Dr. Robert Bagoff, Chair
West Orange Planning Board
66 Main Street
West Orange, NJ 07052

RE: PB-24-01 West Essex Highlands, Inc
Block: 179 Lot: 32 Zone: IH-1 Warner Road
West Orange Township, Essex County, New Jersey

At the request of attorney Bruce Afran, counsel for objectors and We Care NJ Corp., Princeton Hydro has prepared a response to the CME letter dated August 15, 2025 which was addressed to the Chairman and Members of the West Orange Planning Board responding to Princeton Hydro's March 10, 2025 review of the stormwater management system for the above referenced application. Without providing substantial supporting details or evidence, the CME letter generally states that proposed stormwater system is compliant with New Jersey Department of Environmental Protection (NJDEP) design standards and requirements found in NJAC 7:8 and the NJDEP Best Management Practices (BMP) Manual. In lieu of providing any notable supporting reasoning, details or evidence, CME instead simply states and reiterates that the "...Department has determined that this project meets the requirements of the Stormwater Management Rules". In fact, in reference to two critically important points (Time of

Figure 1: Location of Sanitary Line marked (green) to be relocated.

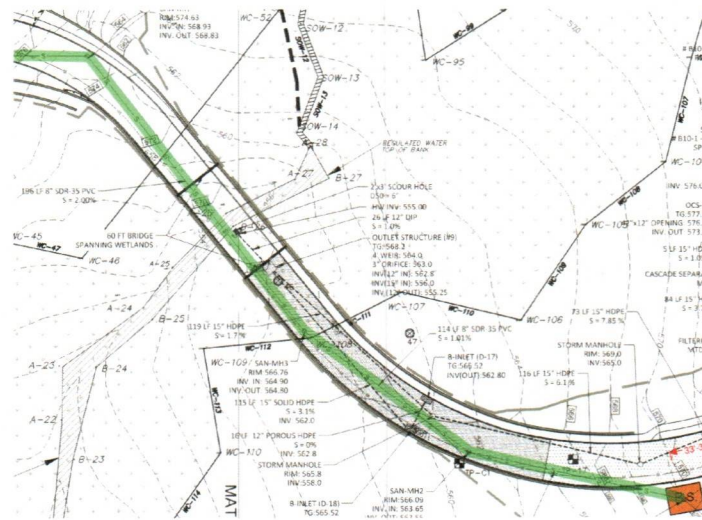
The CME letter states that the sanitary sewer piping will not be installed within any of the stormwater management systems. The applicant's engineer will be required to revise the plans prior to construction. However, as shown in Figure 1 below, the sanitary sewer is surrounded by wetlands. Therefore, relocating this pipe will most likely require additional wetlands permitting; a fact and supporting context/information not provided by the CME letter.

The relocation of the sanitary sewer out of a proposed stormwater management feature represents the only instance where CME as the municipal engineer is requiring the applicant to revise the plans, while they chose to defer to the NJDEP in all other instances. As stated in our original letter, this design feature is inconsistent with sound engineering practices. Although CME did not appear to take issue with this design flaw in their latest review letter, CME has a responsibility to provide an explanation why they chose to defer to the NJDEP on multiple critical design issues (Time of Concentration methodology/analysis and groundwater mounding) and why they chose not to defer on this issue. It is also important for the public to see a revised plan to understand how the applicant contemplates addressing this issue and how a modified design would achieve compliance with the Township's ordinance while also satisfying NJDEP freshwater wetland and flood hazard area regulations.

Figure 1: Cross Section of PP6, Proximity of TP-4 to PP6 and TP-4 Soil Profile.

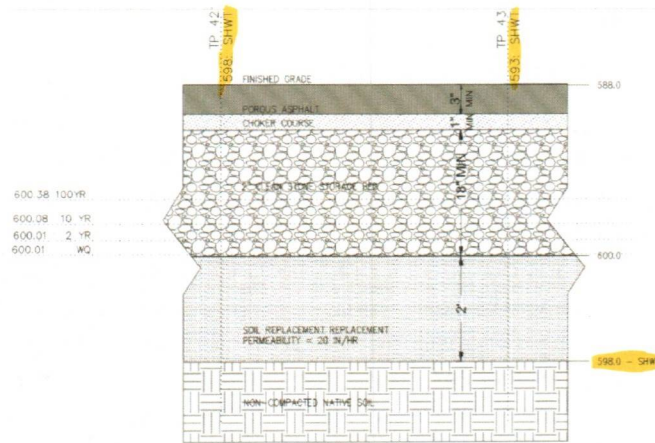
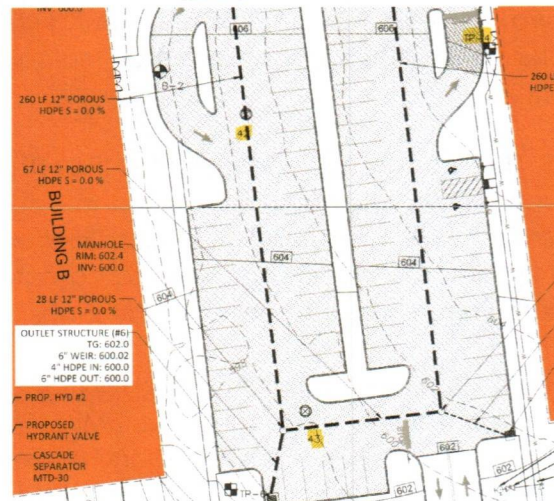
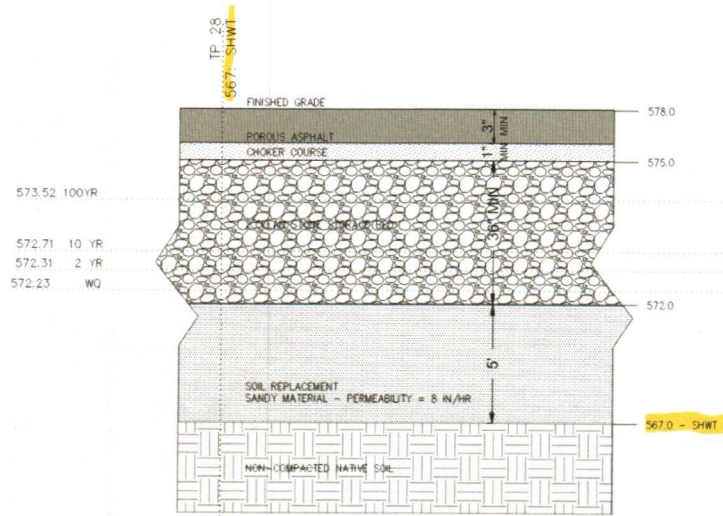
BMP 6 shows a SHWT of 598 using the 2024 soil testing data but the 2021 testing data shows a different story. In 2021, TP 4 shows seepage at 608 which is 10 feet higher than what the plans show. Based on this finding, the porous pavement design is not compliant. The SHWT (which in this case was direct seepage) is within the storage volume of the basin see Figure 1. BMP 4 shows a SHWT of 567 (Figure 2) on the plans but that is only using data from the soil tests taken in 2024 (Test Pit 28). In 2021, soil tests were also taken, and TP 10 (Figure 5) is very close to BMP4. TP 10 shows a SHWT of 573 (Figure 2) six feet higher than TP 28 which would result in the groundwater level being within the storage bed of the BMP, which clearly does not comply with the two-foot minimum separation and would result in a non-functional BMP. There is also an error on the TP-10 soil profile. On the right-hand side of the document, there is an entry for the water level found; however it is left blank. Elsewhere on the same test pit log it states that seepage was found at 3 feet below grade which is an elevation of 573 ($576-3 = 573$). Groundwater seepage is water leaking through the side walls of the soil profile, the seepage is an indicator of the SHWT and it should have been marked that way.

These findings show that BMPs 4, 6 and 9 are not compliant with NJDEP. The SHWT is too high and would occupy a portion of the storage volume of each of the BMPs. This would result in less groundwater recharge than calculated in the stormwater report and higher peak flow rates from each BMP. The BMPs need to be revised. These revisions could require the BMPs to be widened, shortened or relocated in general. The bottom of the BMPs need to be maintained at the minimum of two feet above the SHWT to meet the requirements. This is another way that the design is not demonstrating compliance with N.J.A.C. 7:8 5.4 (Local Ordinance 25-29.4 P) 7:8 5.6 (Local Ordinance 25-29.4 R).

Figure 4: Cross Section of BMP 3.

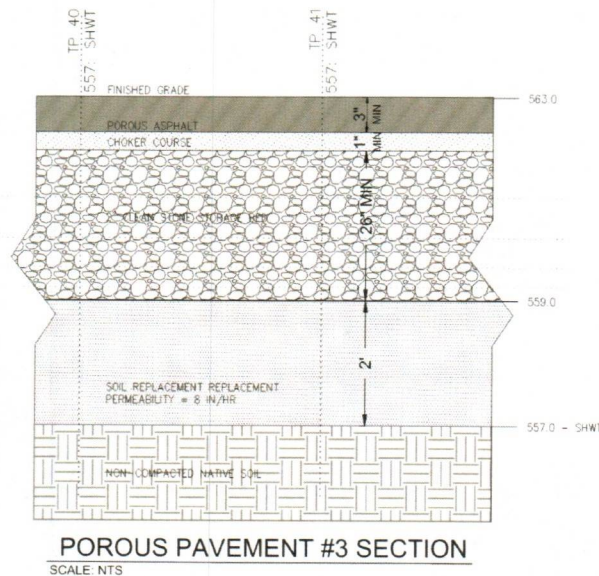
Princeton Hydro will rely on PP3 as an example of the analysis that was performed on each of the BMPs to determine the mounding issue under the 100-year storm scenario. Princeton Hydro observed that the duration of infiltration in the groundwater mounding analysis for the water quality and the 100-year storm, were nearly identical for both storms (0.21 hours for water quality and 0.2 for one hundred year). The analysis for the water quality storm can be found on page 821 of 946 in the Drainage Report and the analysis for the 100-year storm on page 831 of 946 in the drainage report. The duration of these two different elements of a storm event should be very different. The water quality storm is only 1.25 inches where the 100-year storm is 8.33 inches. That is almost 7 times more water in the 100-year storm, due to the sheer volume difference the time should also be substantially different. The recharge rate is also different for both storms, Princeton Hydro does not know why the recharge rate would have different values for the different storms and maintains that it should be the same for any storm.

As noted previously, the design proposes to replace the existing soil from the bottom of the BMP down to the SHWT with a sandy soil that has a higher hydraulic conductivity to allow the runoff to infiltrate quicker through the BMP storage area. However, the native soil at the SHWT still has a very low hydraulic conductivity so the "infiltrated runoff" from the BMP will back up in the replacement soil since the soils at and below the SHWT infiltrate at a much slower rate. Typically, the stormwater report would provide calculations demonstrating that there was enough storage in the replacement soil to hold the "infiltrated runoff" while it infiltrates below the SHWT at a much slower rate. The calculations would show that the "infiltrated" runoff would be held in the replacement soil and not mound into the storage volume of the BMP. Groundwater mounding into the storage volume would directly impact the runoff peak flow rate calculations and the groundwater recharge calculations by reducing the amount of stormwater volume that could be managed by the BMP.

During the water quality storm, BMP 3 infiltrates 880 cf of runoff. The area of the infiltration basin is 5,558 sf. 880 cf of water is equivalent to about two inches of water over the area of the basin. That means that two vertical inches of water will be held above the SHWT and slowly infiltrate. Assuming a porosity of 0.4 for the sand layer, the two inches of vertical water turns into five inches. That means that there is five inches of water in the sand layer between the SHWT and the bottom of the storage for PP3. The system works under this scenario because the soil replacement area is two feet deep. However, during the 100-year storm, the model assumes that 10,971 cf of water will infiltrate through the system (page 529 of 946 in drainage report). That is because the model is assuming the runoff is infiltrating at a constant rate of five inches per hour. The reality is that at the surface of the basin at the beginning of the storm, the runoff will infiltrate at that rate but once it hits the SHWT it will infiltrate at the much slower rate of 0.25 inches/hour (assuming a factor of safety of 2, based on the soil testing results) that will cause water to back up into the sand layer. Once the system is under the influence of a groundwater mound the rate of infiltration could be expected to decrease by orders of magnitude as the system will rely on horizontal groundwater flow. There needs to be thick enough layer of sand to prevent that runoff from backing up into the storage area of the BMP3. 10,971 cf of water over the area of the basin is equal to 1.97 ft of water. As noted above when you apply the 1.97 feet of water to the anticipated porosity of sand (0.4), the height of the sand and the water is 4.9 feet (59 inches) from the SHWT. BMP 3 (see Figure 4) only provides two feet of sand storage and an additional 26 inches of stone storage (see Figure 7). The system will become overwhelmed during a 100-year storm and the peak flow rates will not be reduced. Instead of infiltrating, a large portion of the 10,971 cf that the model says will infiltrate will discharge through the stormwater system. The design will fail and potentially create higher peak flow runoff rates than currently exist. Furthermore, this design issue is not isolated to BMP 3 since any unanticipated surcharge from the BMP will be captured by inlets further downstream and will potentially overwhelm those inlets. If the excess runoff is captured by the inlets, the runoff will enter either BMP 1 or 2, it could overwhelm those systems and increase the peak flow rates from those BMPs as well.

Figure 5: Proposed Grading Plan with Blue Arrows showing the existing drainage path and the Fuchsia arrows showing the proposed drainage paths and how the runoff is being diverted from the wetlands.

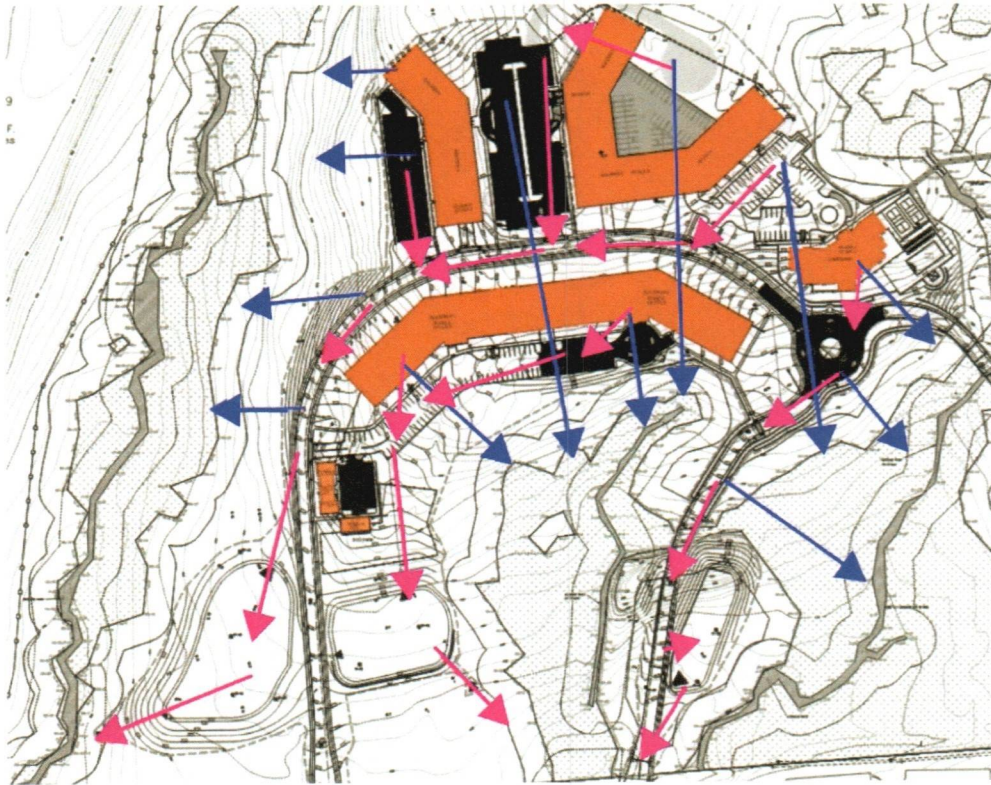
In the existing conditions, the stormwater runoff generated from the existing topography travels over the surface and reaches the upgradient wetlands providing valuable water to the wetland ecosystem. In the proposed condition, the discharge locations for each of the drainage areas are at the bottom of the project area. This is illustrated in Figure 5. The blue arrows show the existing flow paths and the fuchsia arrows represent the proposed flow paths. The proposed stormwater system intends to route the stormwater runoff through a pipe network to basins where all the surface runoff will discharge much further downstream. The drainage area to the wetlands uphill of the discharge locations will have a smaller drainage area and collect less stormwater runoff. Princeton Hydro included two attachments that show the existing drainage areas for eastern and western wetlands. The western wetlands have a drainage area of approximately 32 acres. The proposed improvements to DA for the western wetlands will reduce the drainage area by nine acres or 28% of the total existing drainage area. The eastern wetlands have a drainage area of 48 acres. The proposed improvements to the DA for the eastern wetland will reduce the drainage area by 16 acres or 33% of the total existing drainage area.

In addition, to the modified drainage areas to the wetlands there are at least two instances where the proposed design will result in the hydrologic gradient of groundwater to the wetlands being modified and redirected toward two of the proposed infiltration basins, BMP 2 and BMP 7. For example, the bottom of BMP 2 is at elevation 544 (this is incorrectly identified as being 544.5 on plan sheet SP-55 as the bottom of the basin should be the base of the 6-inch sand layer). Figure 6 shows a cross section of BMP 2 with the elevations of the adjacent wetland. In this case, the basin bottom is situated as much as six feet below the elevation of the wetland which is less than 75 feet from the wetland to the east (see Figures 6 and 7). More importantly, the groundwater data indicates that the SHWT for boring six is approximately ten feet lower than that of the surface of the nearby wetland. In addition, TP22 is located approximately fifty to the

northwest of the basin and the SHWT is indicated to be at an elevation of 545, a foot above the basin bottom. It is important to reiterate that no redoximorphic features were identified by the applicant's professionals in any of the borings.

Figure 6 Cross section of BMP 2 from the construction plans.
 The red lines mark the surface elevation of the nearby wetland.

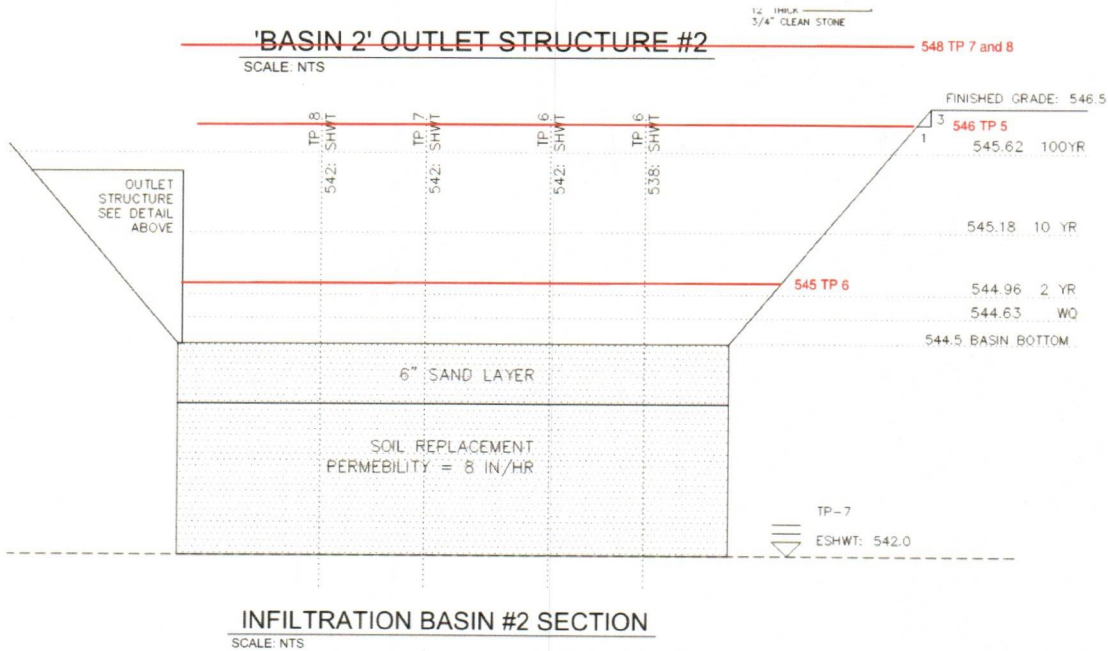
Both BMP 2 and 7 are proposed to be excavated to an elevation below nearby wetlands. In these cases, the proposed BMP would result in the disruption of the current hydrologic gradient toward the wetland to one that redirects the hydrologic gradient toward the BMPs from the wetland. This will not only impact the wetland but will add an additional source of water to the BMPs that has not been identified by the applicant. This is especially relevant for BMP 7 where the basin is proposed to be excavated to an elevation approximately 16.5 feet lower than the delineated wetland located a little over 50 feet to the north of the basin. The relationship of wetlands and state open waters to infiltration basins should have been considered in the design of the proposed stormwater BMPs as the current design will not just impact the function of the BMPs but also impact the wetlands. The impacts to the wetlands related to changes in hydrology also warrants reconsideration by the NJDEP as it relates to the 401 Water Quality Certification the NJDEP granted to this applicant.

Figure 9: Existing Conditions Drainage Path for POA-2, demonstrating how the analysis stops approximately 700 feet short of the POA location.

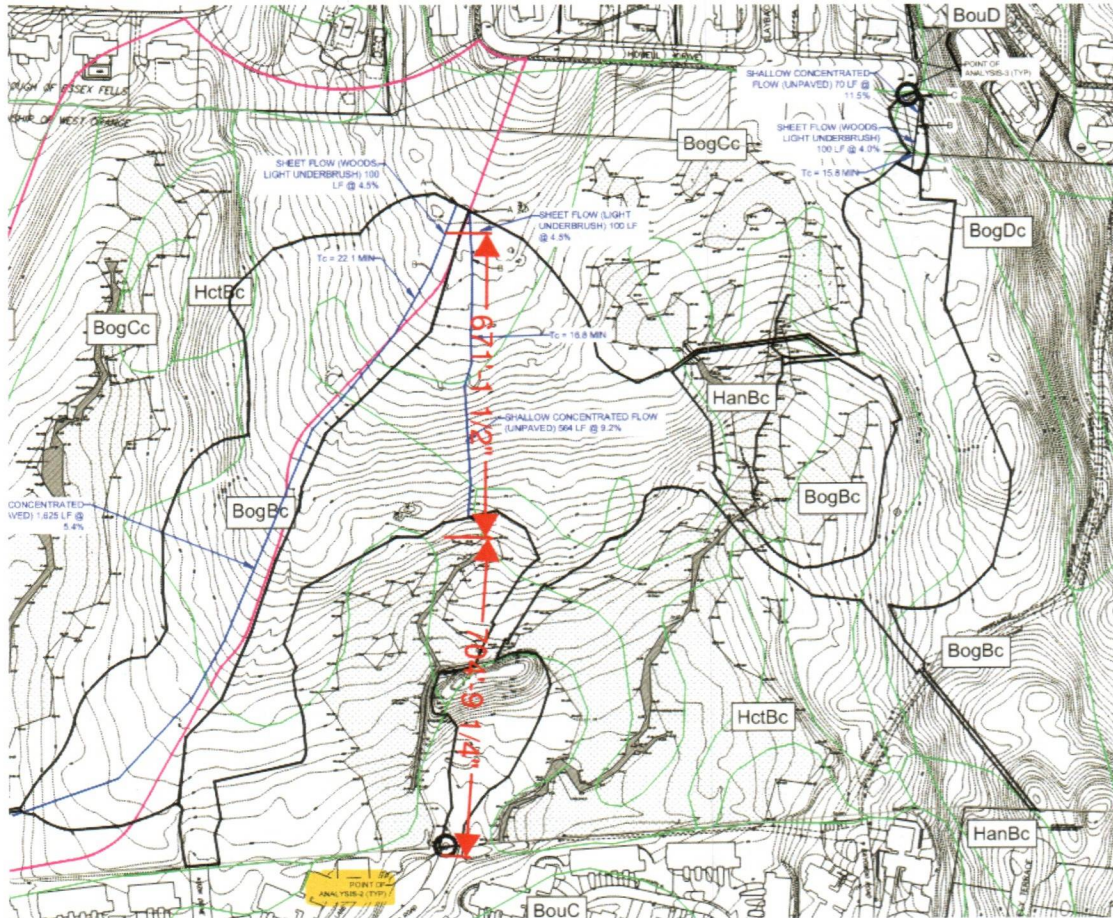
The flow path shown on the Drainage area Map for POA 2 is only 664 feet long and that matches what is shown on the model. The TC is meant to measure the time it takes for the water to travel the entire flow path. The actual flow path for POA 2 is greater than 664 ft. The discharge location is approximately 700 feet away from where the analysis ends (as the crow flies, see Figure 9). This analysis is incorrect and incomplete because it does not capture the entire flow path.

To understand the impact that the TC errors have on the design, Princeton Hydro calculated the TC for POA 2 using the correct method and included the entire flow path. The applicant's report has a total TC of 16.8 minutes. Princeton Hydro's calculations show a TC of 60.8. That is about 3.5 times longer than that calculated by ACS. For the two-year storm, PH calculated a peak flow

model states 14.76 cfs (page 22) while their report states 17.53 cfs (page 14). Princeton Hydro also found that the existing peak flow rates in the report do not match the flow rates in the model results found in the report appendix. This should be corrected. For the purpose of this report, the results found in the modeling calculation appendix were evaluated against Princeton Hydro's own calculations. Based on our calculations the peak flow rate for the development is 3.76 cfs under existing conditions for the two-year storm. Currently the design's peak flow rate under the post-development conditions is 7.24 cfs which is almost twice what should be permitted. Princeton Hydro calculated the peak flow rate for the 100-year storm at 37.7cfs but the applicant's model states the peak flow rate at 72.79. The peak flow rate for the proposed condition is 38.99 cfs. During the 100-year storm, the proposed Site will actually generate higher peak flow rate than what currently exists. This is an alarming situation especially considering there are flood prone areas immediately downstream. To meet the peak flow rate requirements state forth by the NJDEP and the local ordinance would require the volume storage for the BMPs to be dramatically increased. This would have a substantial impact on the current site design.

Figure 10: These are images of DA-1 and DA-2 from the Stormwater report to demonstrate how the DA for POA 2 should be modeled as two separate DA's because there are two separate points of discharge.

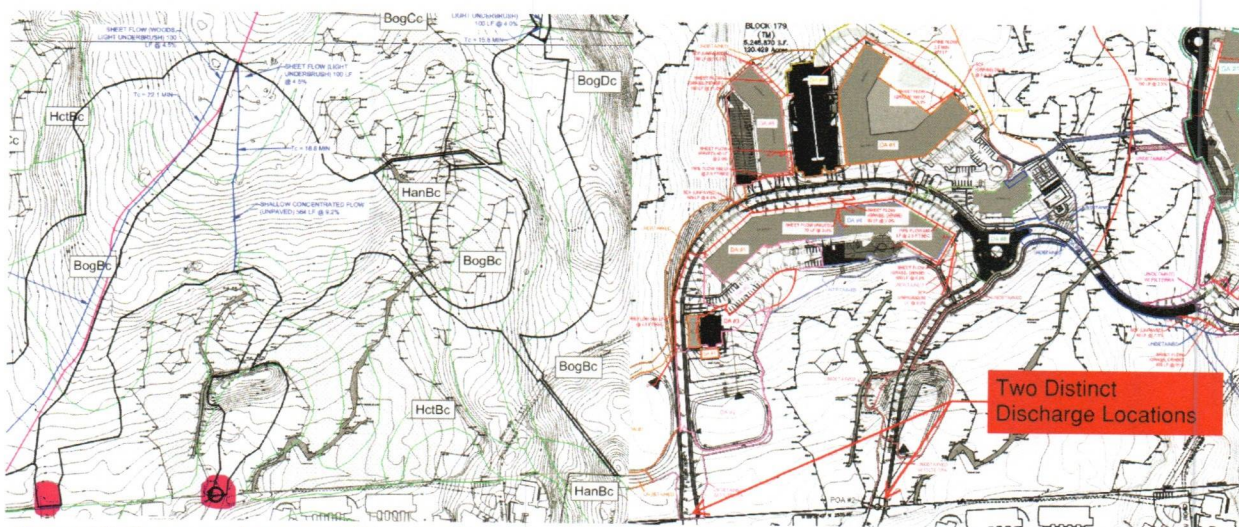
The analysis of the existing drainage area for POA2 has yet another flaw. The drainage area for POA 2 has two clear discharge locations in the proposed condition, but it only assumes discharge location at Kuzik Road (see Figure 10). The design has two discharge locations, but the modeling assumes they are combined. The flows do eventually combine but that is approximately 600 ft into the adjacent neighborhood. The drainage area analysis must be reanalyzed as two separate drainage areas with two separate analyses to ensure the peak flow rate at both locations does not increase. It is difficult to understand at this time how this change will impact the proposed design but it could be substantial. This re-evaluation is necessary to ensure that the peak flow rate of runoff from the Site is compliant with the state and local regulations and to prevent downstream flooding.

Figure 11: Profile of BMP 9 showing a sanitary line traveling through the BMP.

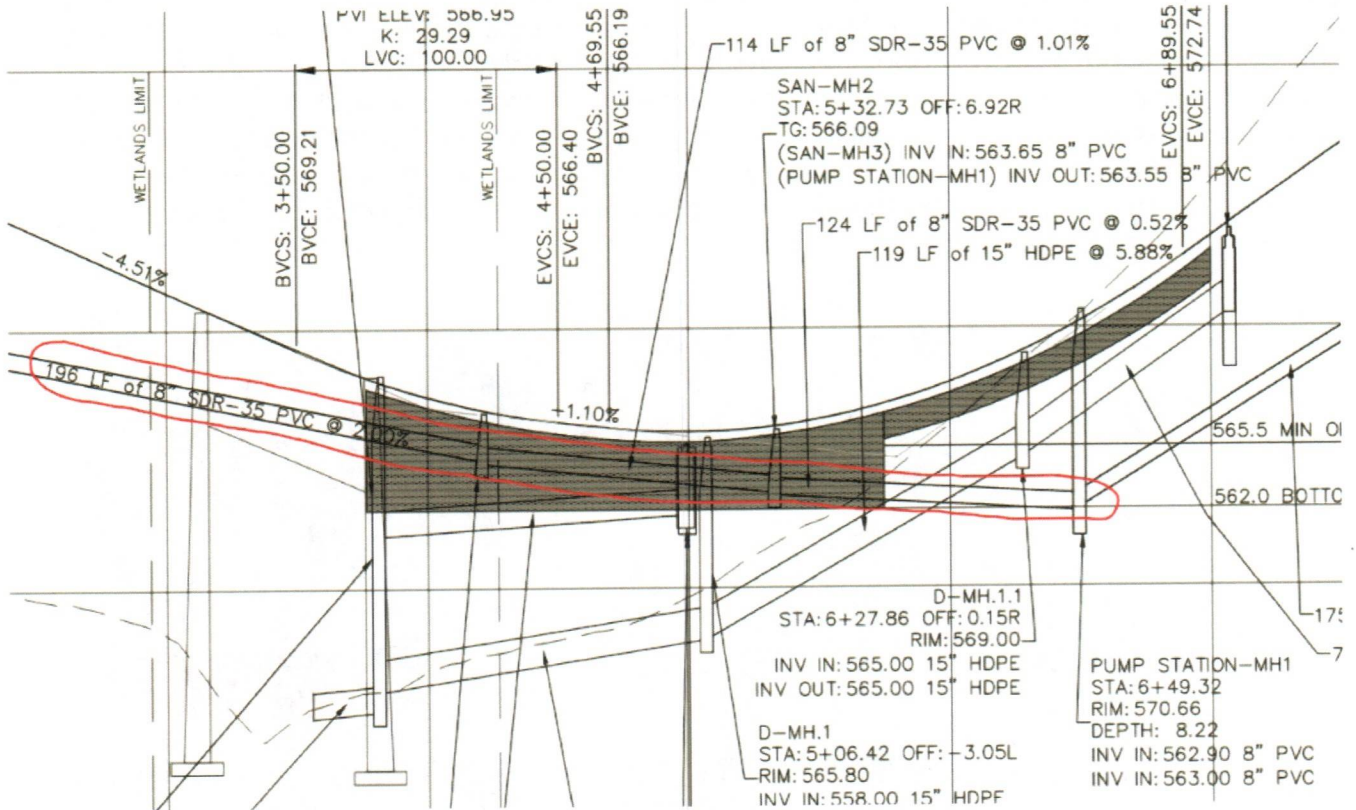
The design has a sanitary pipe traveling through porous pavement system (Figure 11). While we are not aware of a specific rule against having a sanitary line traveling through a subsurface basin, it appears to be a poor design decision that is counter to the rules and common engineering design sense. The purpose of the distances is to prevent leaking sanitary pipes from entering the stormwater system and potentially causing an illicit discharge of raw wastewater. The design should be modified to relocate the sanitary pipe out of the subsurface system. This may require the project to have additional Flood Hazard and/or Wetlands Permitting depending on how the layout is impacted by this modification.
